NUCLEAR REGULATORY COMMISSION

ADVISORY COMMITTEE ON REACTOR SAFEGUARDS

245TH MEETING

DATE: September 4, 1980 PAGES: 1 thru 308

FIGURE 2.2 BWR CONTROL ROD DRIVE MECHANISM (SIMPLIFIED SKETCH)

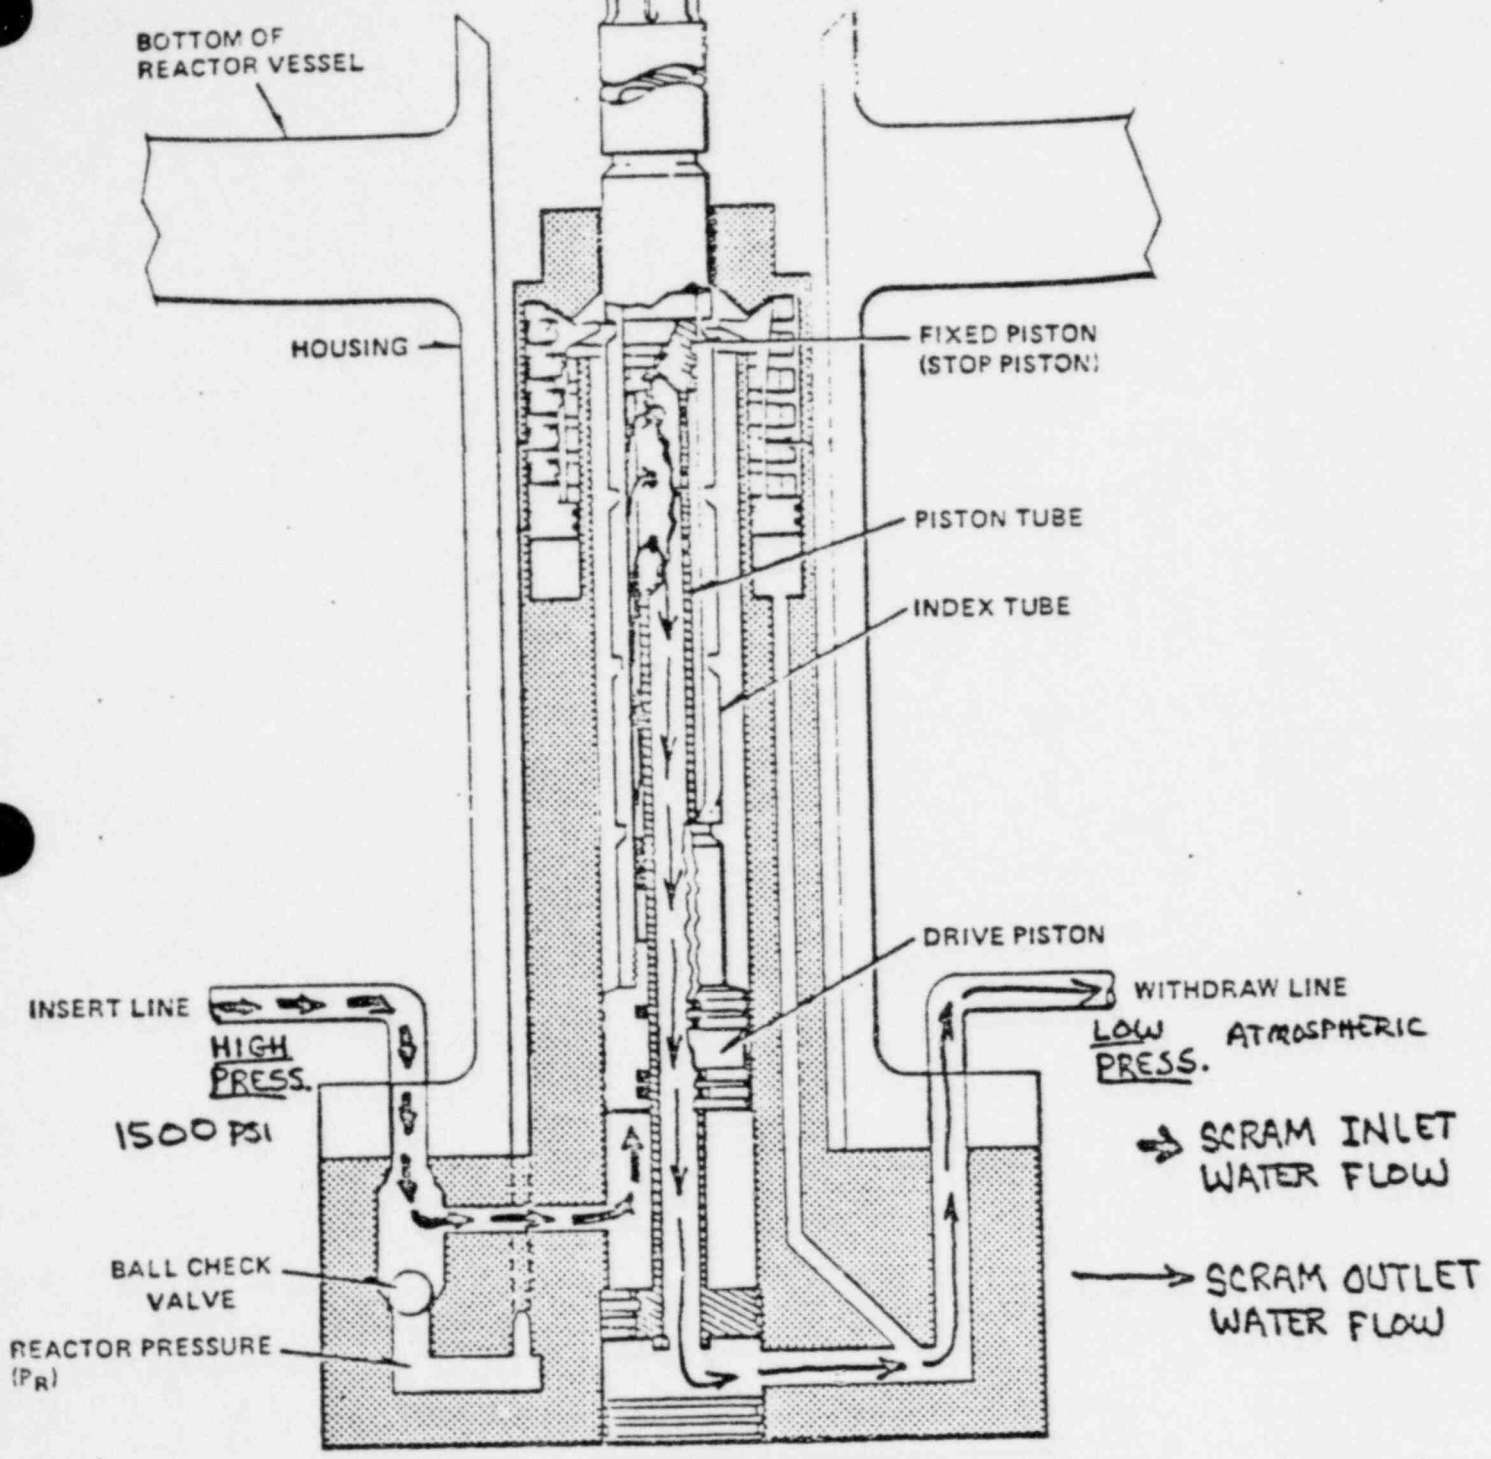
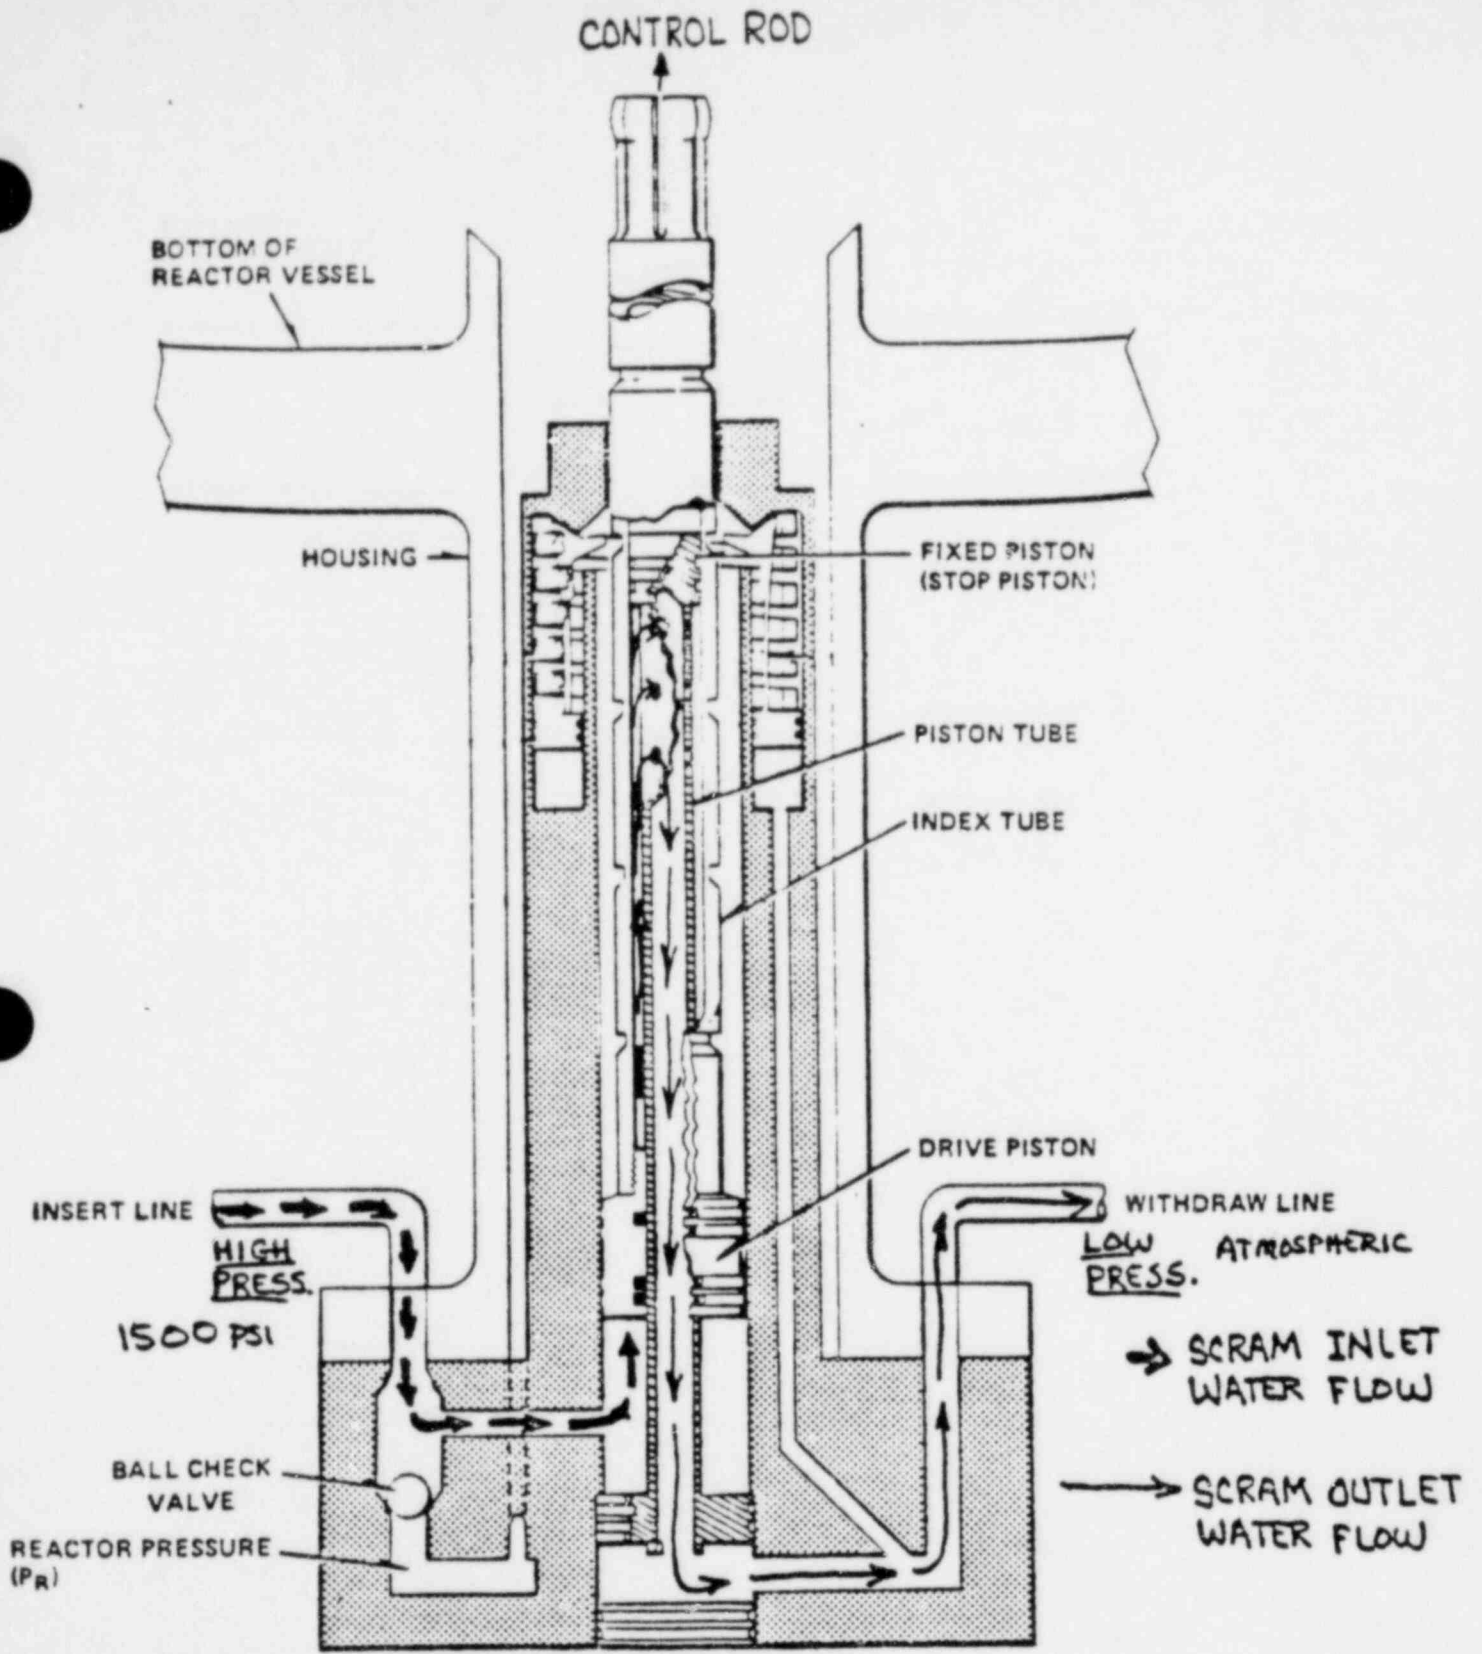
13 MR. YOUNG: This is a schematic drawing of a
14 control rod drive mechanism, and this is the drive piston
15 that pushes the control rod into the fuel assembly area.
16 The way it is supposed to work is the high pressure water is
17 applied to this side of the line, which exerts force on the
18 bottom of the drive piston, pushing it up into the vessel,
19 and then the back side of the drive piston, this area here,
20 is vented via this line to the scram discharge volume, and
21 this is essentially an atmosphere pressure, and this is
22 approximately 1500 psi. So it is a differential system that
23 drives the rod into the core.

FIGURE 2.4 BROWNS FERRY SCRAM DISCHARGE INSTRUMENT VOLUME

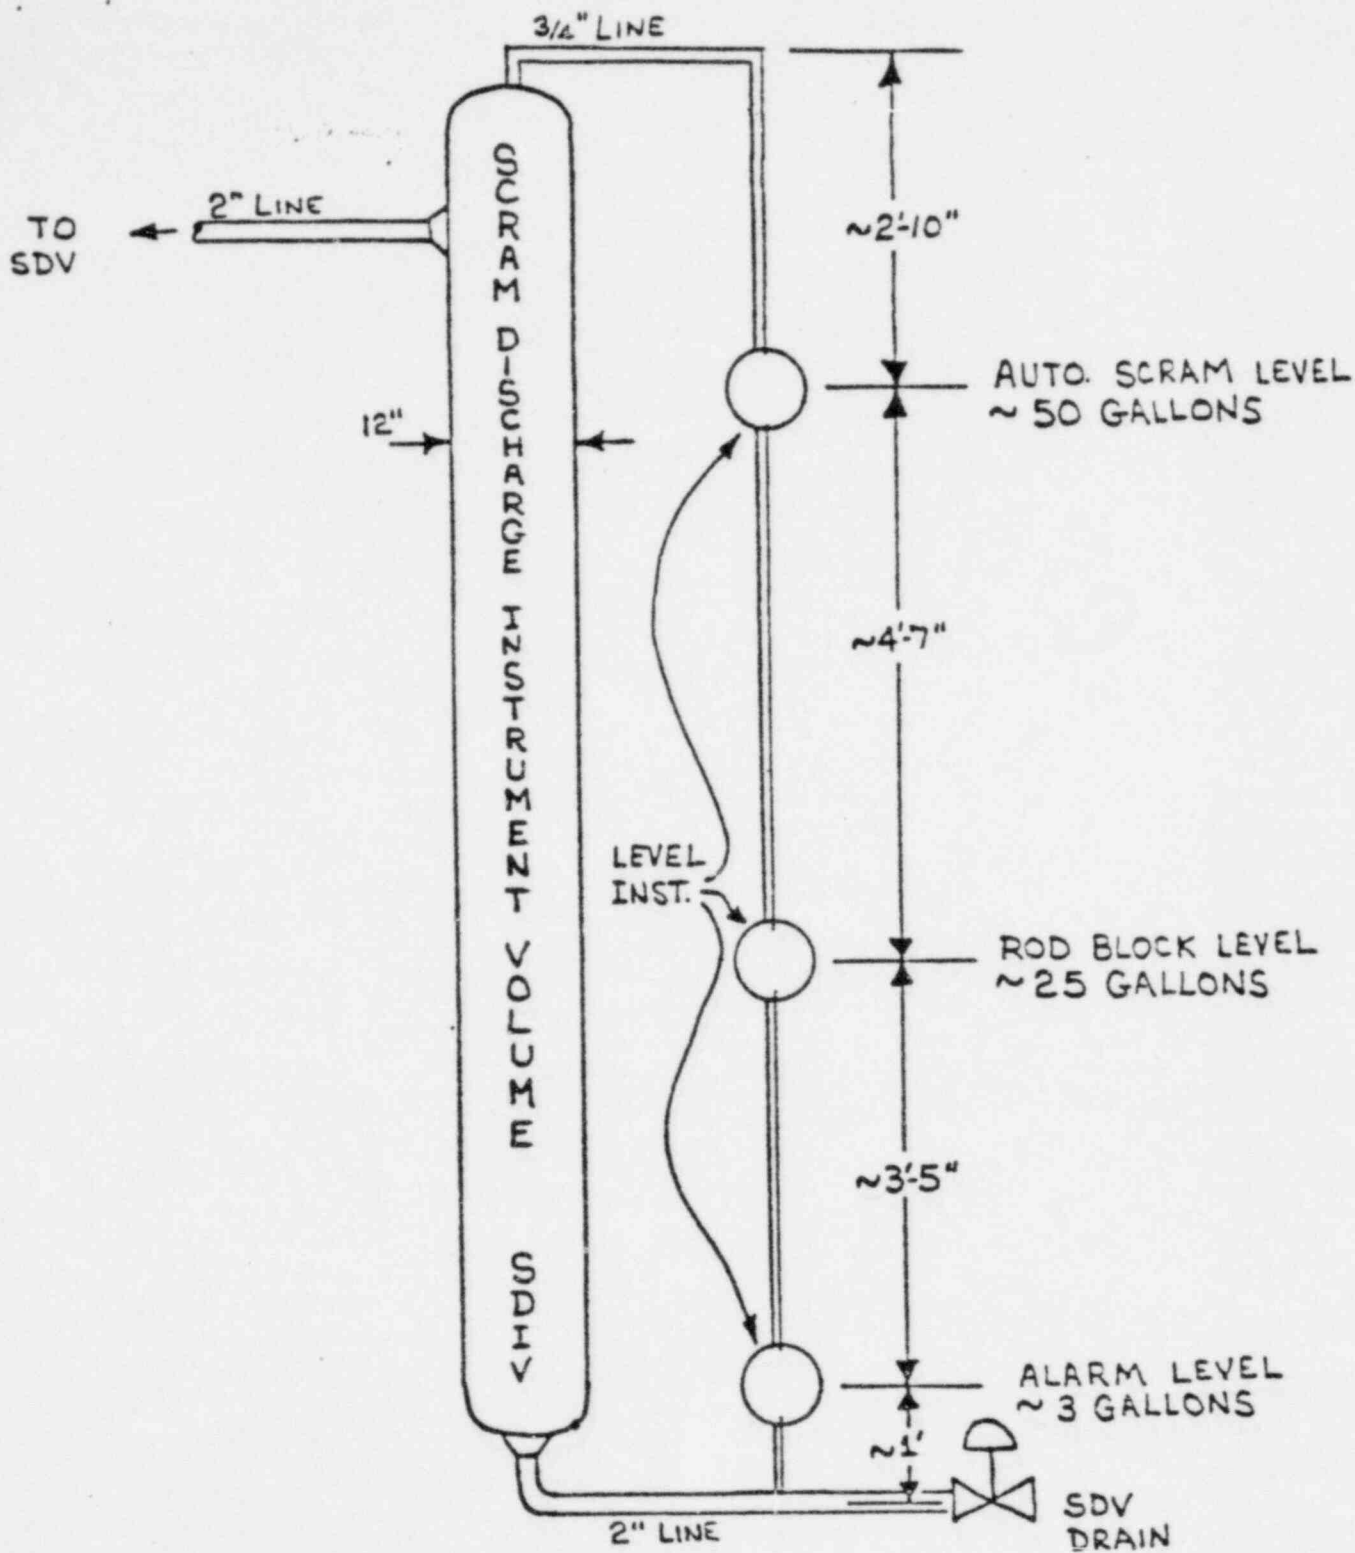
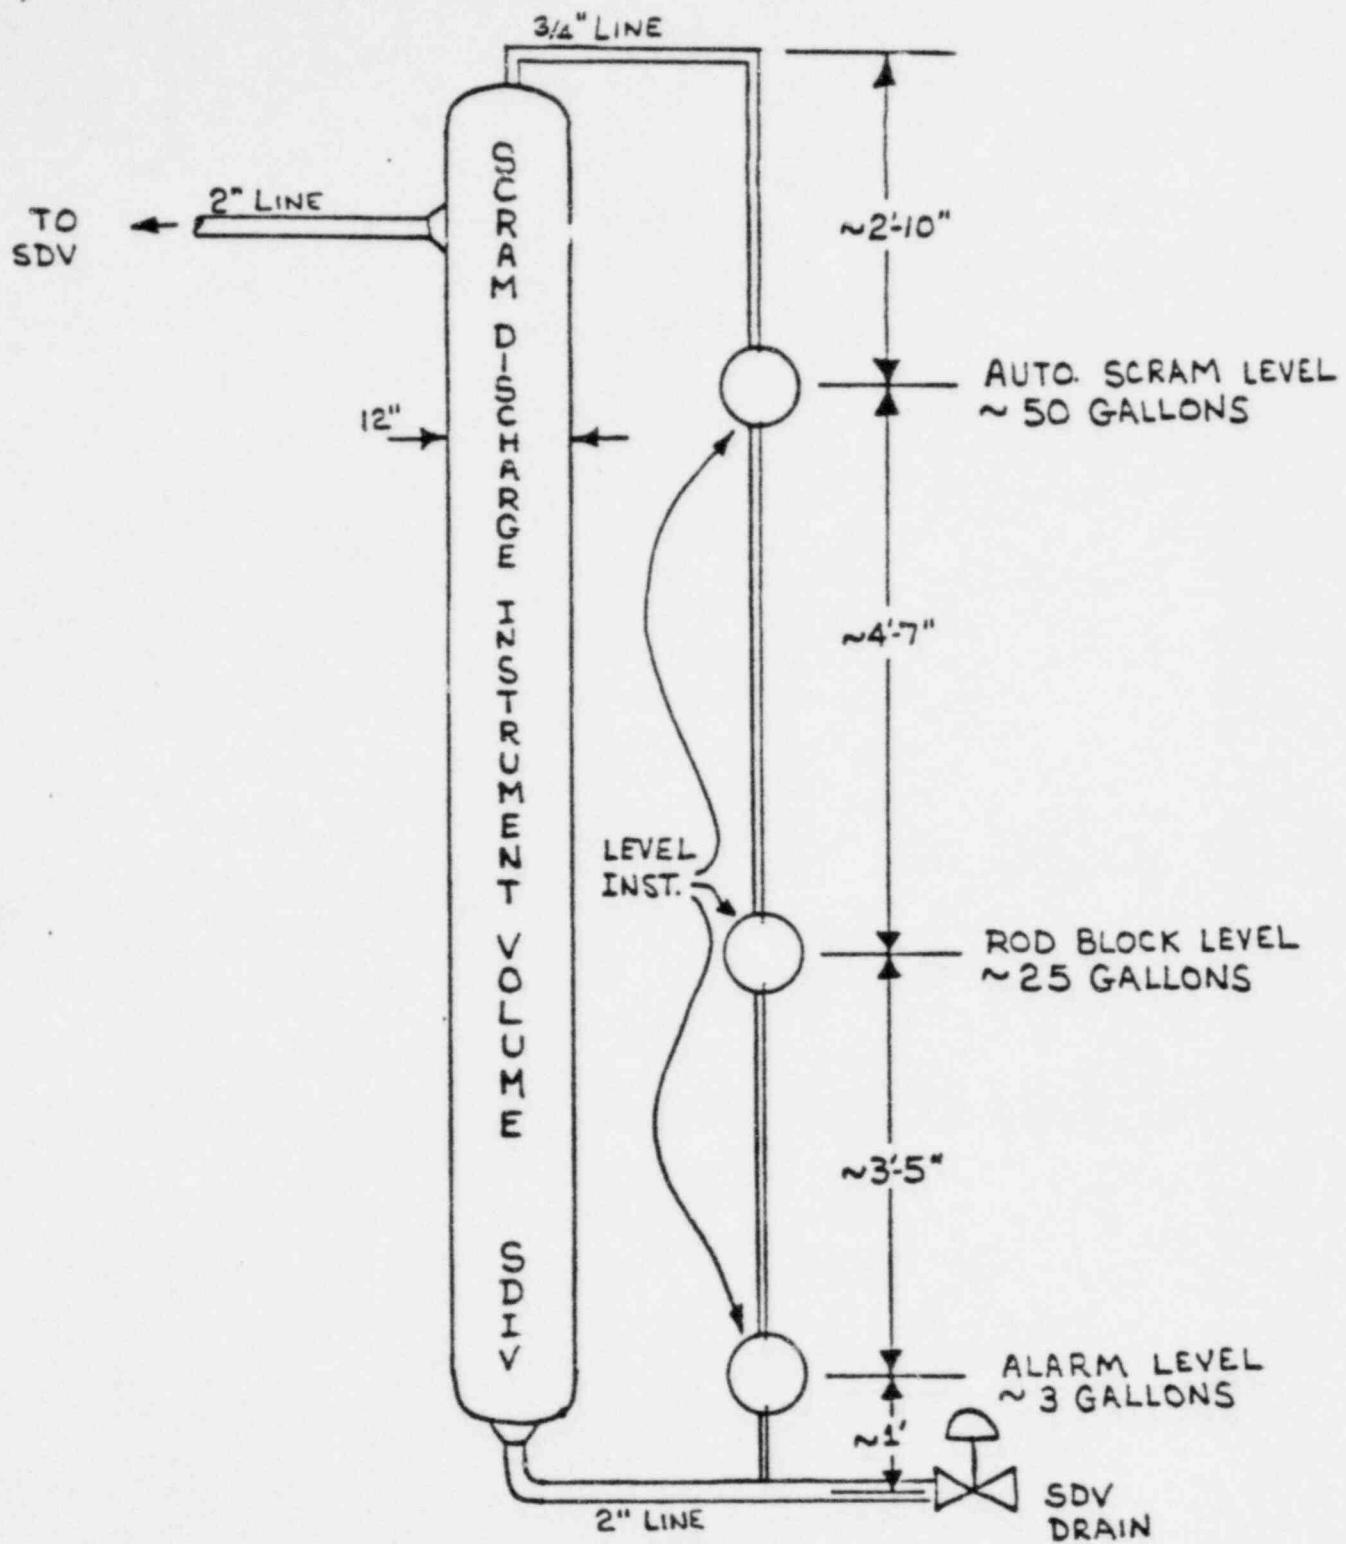
13 But what happened at Browns Ferry simply was that
14 this header filled with water, and as it ran into the
15 instrument volume it was not picked up by the instruments
16 because -- well, I will show you. I have another drawing
17 that shows that a little better.

2 Now, at this point since you still have fresh in
3 your mind what Browns Ferry looks like, I would like to go
4 through and show you the difference between the instrument
5 volume on these two plants. Notice that the scram level
6 switches come off, the scram level and the rod block level,
7 come off the instrument volume itself. The alarm level is
8 connected to the drain line.
